SOIL AND WATER RESPONSES

Figure 83-1

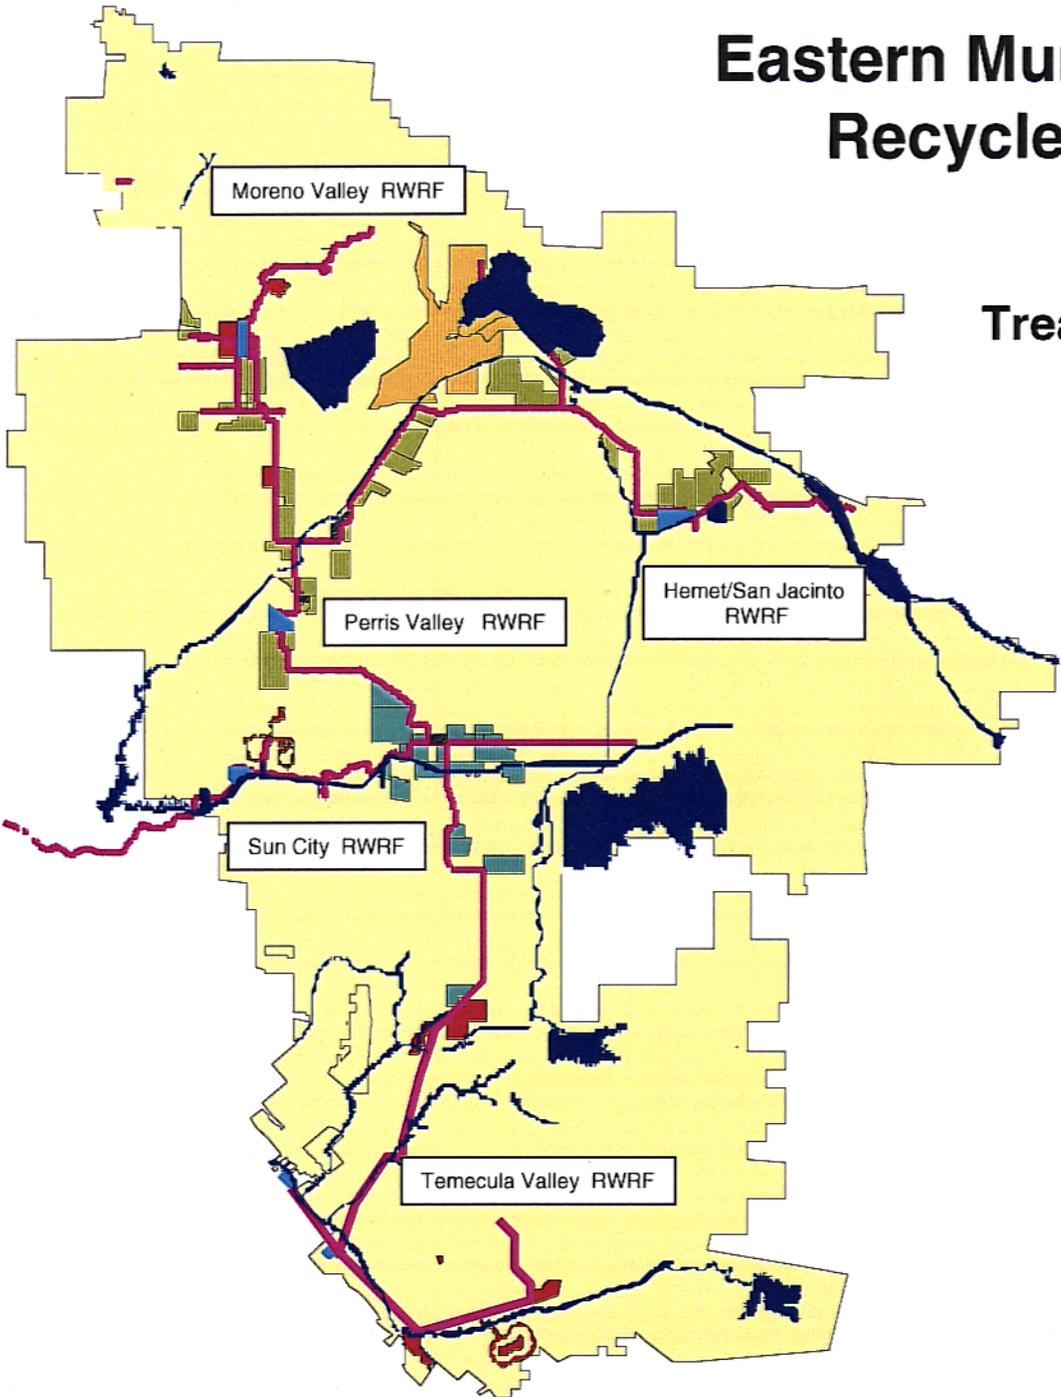
Request #83 - Please provide a schematic diagram of the various recycled water supply sources, uses, and storage accumulation/depletion on a peak summer day, as well as on a base line basis, to better explain their relationships. Please explain the transfers shown in Table 5.4-4 and any associated impacts on the source of these transfers on fresh surface water supplies in other areas.

Response #83 - Figure 83-1 is a schematic diagram of the EMWD regional water reclamation facilities, which constitute the source of recycled water on the EMWD system and the major distribution facilities. Also depicted are the current uses and storage facilities.

Table 83-1 describes the current capacity and current flows through each of the regional water reclamation facilities. As shown, EMWD currently produces approximately 32 MGD of recycled water on average through 4 regional treatment plants with a total capacity of 49 MGD. Please note that flows from the Temecula RWRF would not be allocated to IIEC because system constraints may limit the ability of EMWD to supply water from this source to IIEC. EMWD has considered only supplies from the Hemet, Moreno and Perris plants when estimating the availability of recycled water to serve IIEC. On the table, the monthly

Figure 114-1

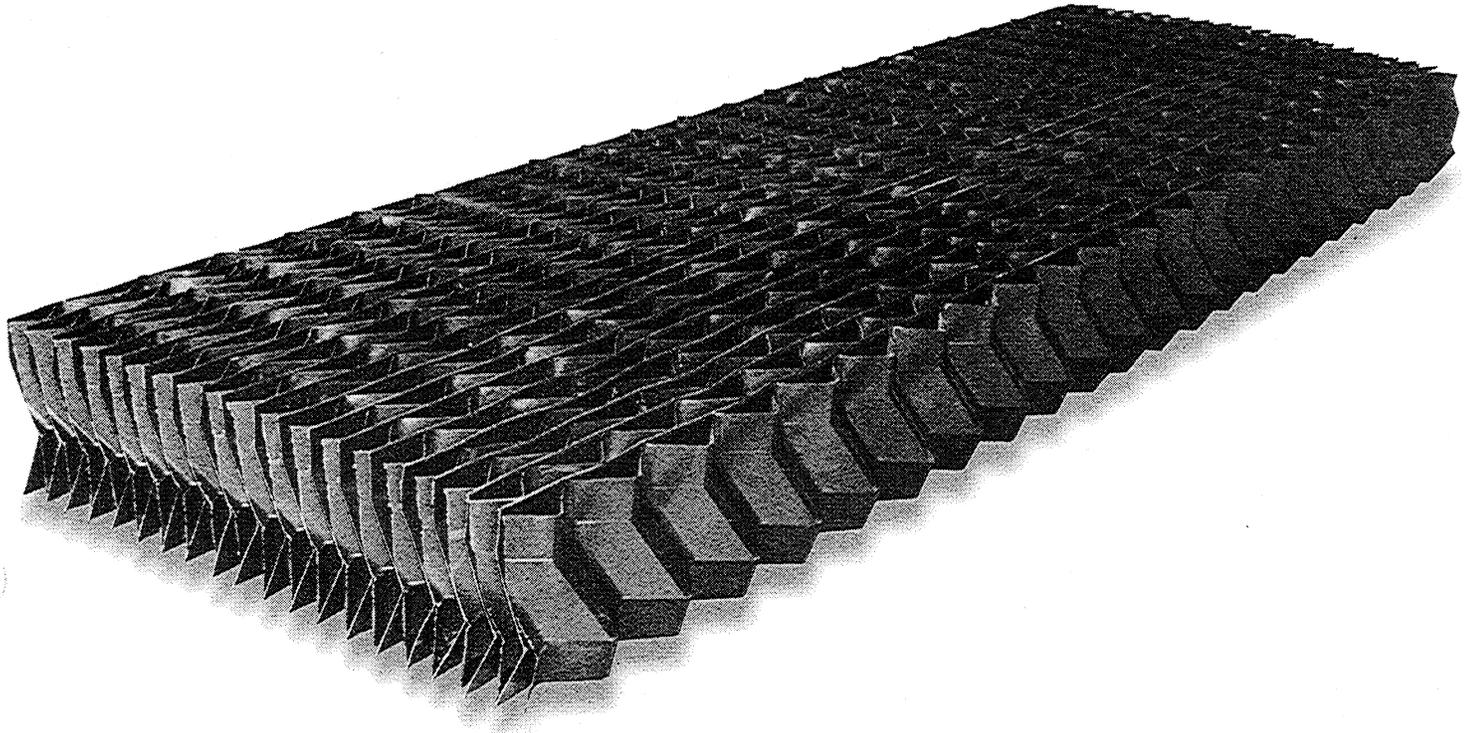
Request #114 - Please provide a cooling tower manufacturer’s recommended features to reliably achieve this drift loss. Consideration should be provided to; drift eliminator configuration, impingement area, and separation from fill; whether the drift eliminator will be interrupted by the cooling tower structural frame; method of fan speed control; vertical air flow rate; and water loading rate.

Response #114 - While a cooling tower drift rate of 0.0005 percent of the circulating flow may be less than that of many operating cooling towers, it is offered and guaranteed by all cooling tower manufacturers who will be on the Applicant’s list of acceptable manufacturers for IEEC. Figure 114-1 is drift eliminator catalog cut from one manufacturer, Marley, indicating the commercial availability of a 0.0005 percent drift rate. The cooling tower for the IEEC has not yet been purchased; therefore it is not possible to provide the design details listed in this data request at this time. Furthermore, these details (i.e. drift eliminator configuration, impingement area, drift eliminator separation from fill, whether or not fill is interrupted by the cooling tower structural frame, vertical air flow rate, and water loading rate) are factors that are considered by the manufacturers in the design of the cooling tower as necessary to meet the guaranteed performance and are not typically details that the Applicant determines.

Figure 115-1 – New EMWD Linear Facilities to Serve the IEEC

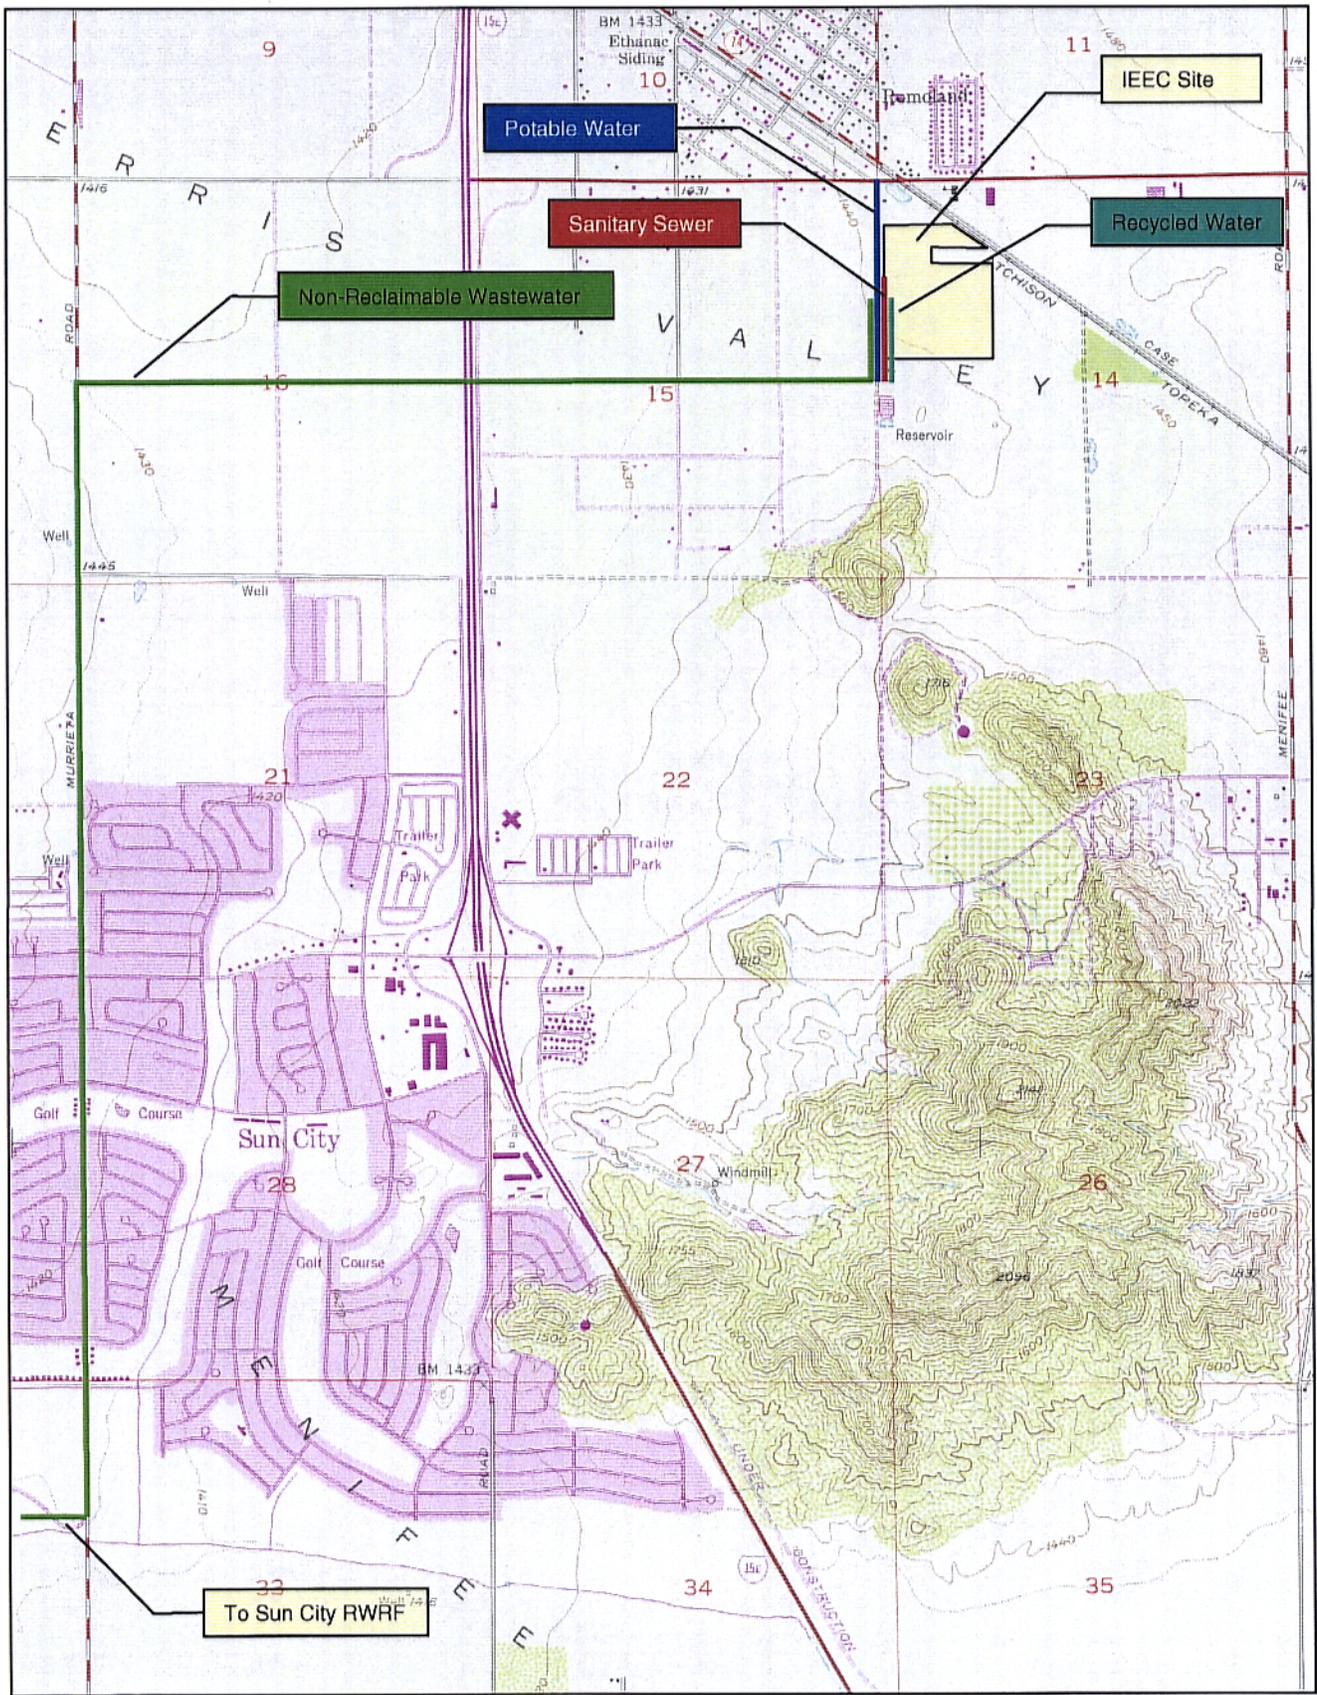
Request #115 - Please provide a revised site map illustrating locations of these existing and proposed facilities, and provide a description of the proposed interconnection between raw and recycled water systems, demonstrating the ability to avoid backflow of recycled water into the raw water system.

Response #115 - As discussed in Section 3.4.9 of the AFC, recycled water will be supplied to the IEEC from a new lateral pipeline connecting to an existing EMWD 48-inch recycled

water pipeline located in McLaughlin Road, just south of the project site. The new lateral pipeline will be located in the Antelope Road right-of-way and owned by EMWD. Figure 115-1 shows the location of the proposed new EMWD linear facilities, including pipelines for recycled water, potable water, non-reclaimable waste, and the sanitary sewer.
